CITY OF ALBUQUERQUE

**Re: Gracia Cadillac
1220 S. Renaissance
Traffic Circulation Layout
Engineer's/Architect's Stamp 02-21-20 (F16-D003I)**

Based upon the information provided in your submittal received 02-24-20, the above referenced plan cannot be approved for Building Permit until the following comments are addressed:

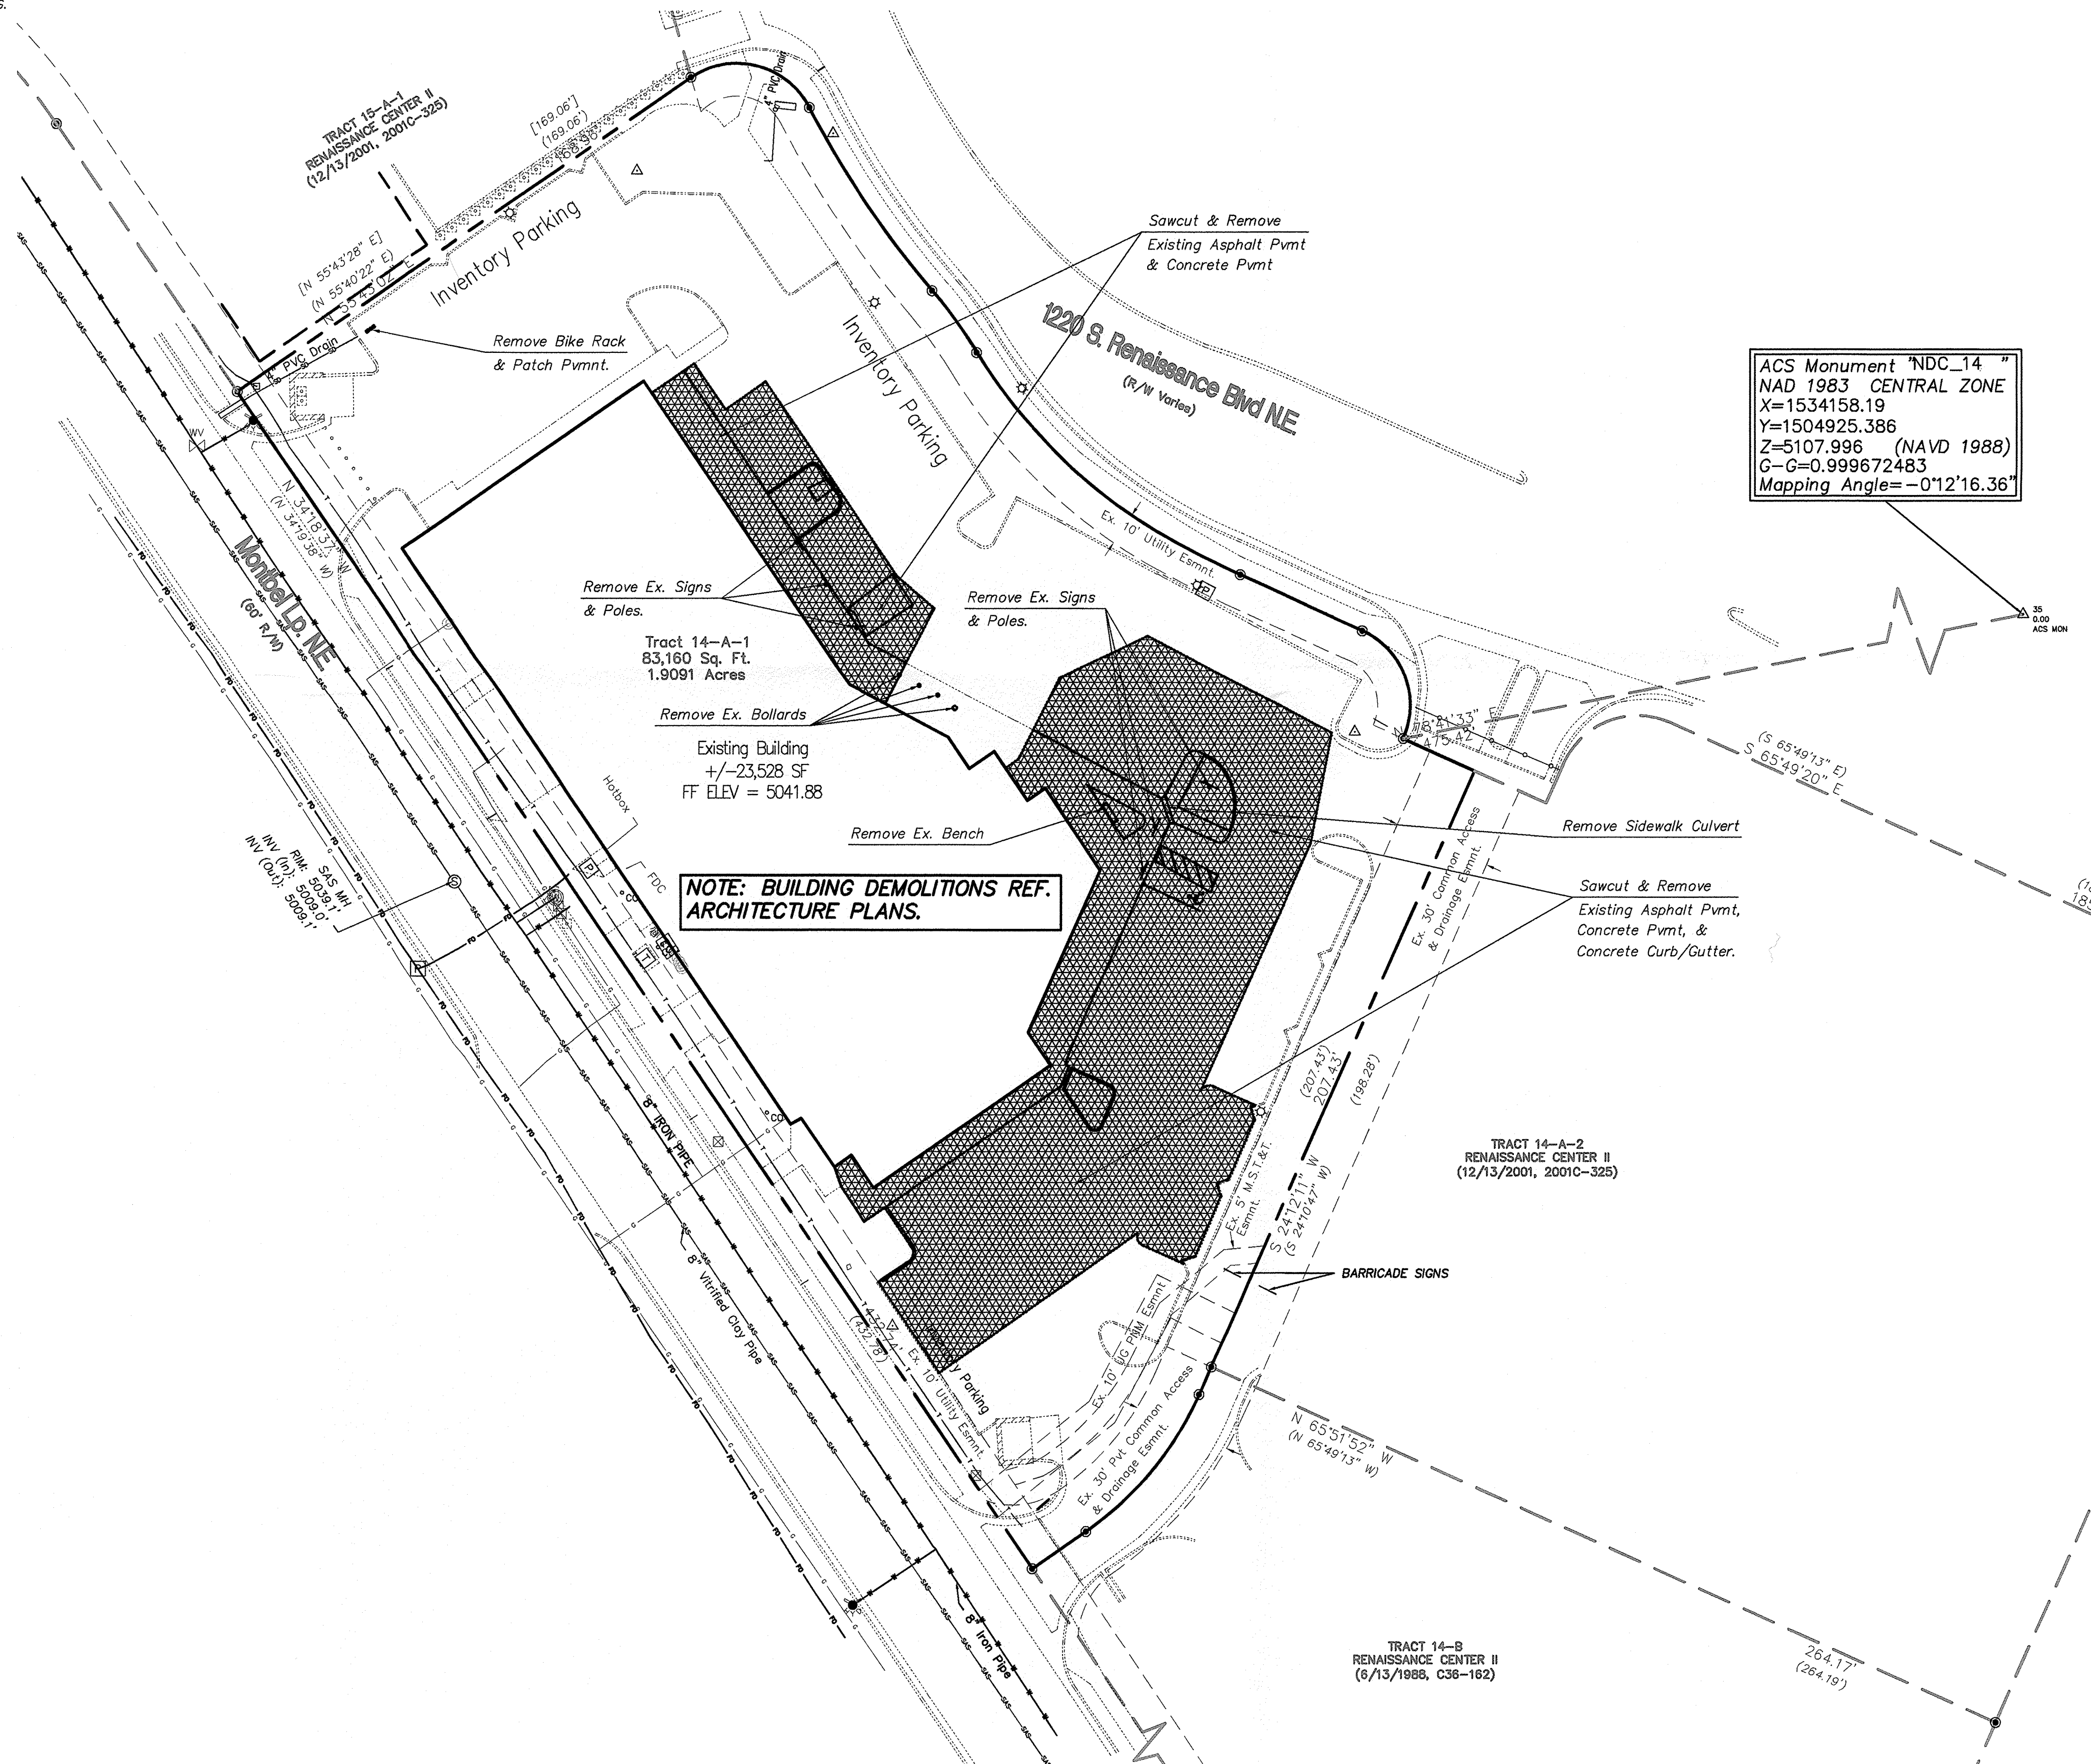
- Provide widths for proposed and existing conditions, on stalls, sidewalk parking

Urban Rack (UB-1000-STD)

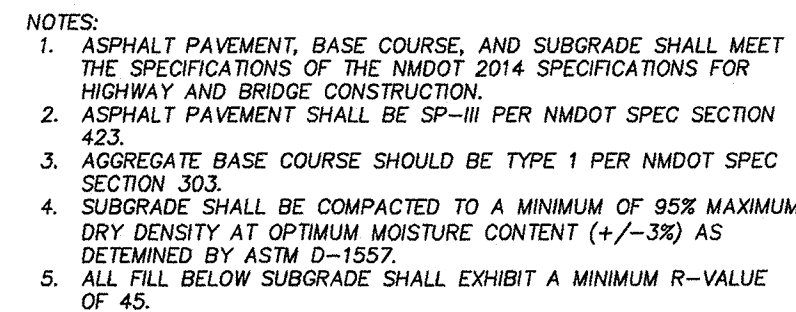
- a. The rack shall be a minimum 30 inches tall and 18 inches wide.
 - b. The bicycle frame shall be supported horizontally at two or more places. Comb/toaster racks are not allowed.

- c. The rack shall be designed to support the bicycle in an upright position. See the IDO for additional information.
 - d. The rack allows varying bicycle frame sizes and styles to be attached.

- e. The user is not required to lift the bicycle onto the bicycle rack.
 - f. Each bicycle parking space is accessible without moving another bicycle.

- g. **Proposed location is a safety concern. Please provide an alternate location.**
5. Bicycle racks shall be sturdy and anchored to a concrete pad.
6. A 1-foot clear zone around the bicycle parking stall shall be provided.
